Recall 14V-264 Cam Chain Tensioner 2nd SUPPLEMENT

**C 600 Sport (K18)
C 650 GT (K19)**

**Service Information No. SI 11 002 14 (021)R
11 Engine**

2nd SUPPLEMENT: Technical Campaign: timing chain tensioner C 600 Sport (K18, 0131/0132), C 650 GT (K19, 0133/0134)

Figure: Timing chain tensioner with production date (arrow)

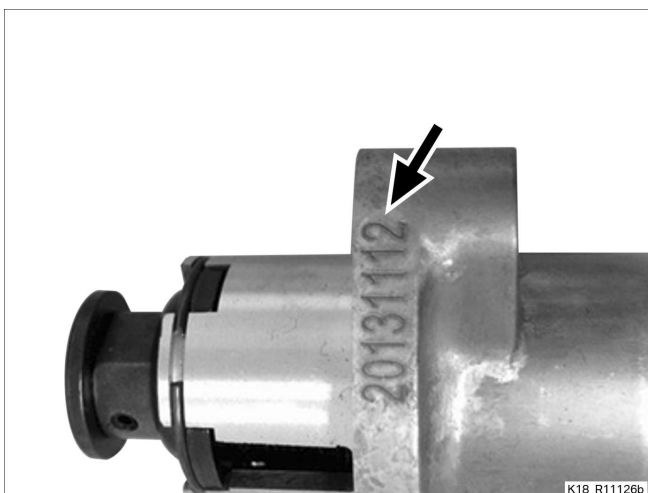
From engine number 70020276, improved timing chain tensioners are installed in the series. Only one date of manufacture is put on the improved timing chain tensioner.
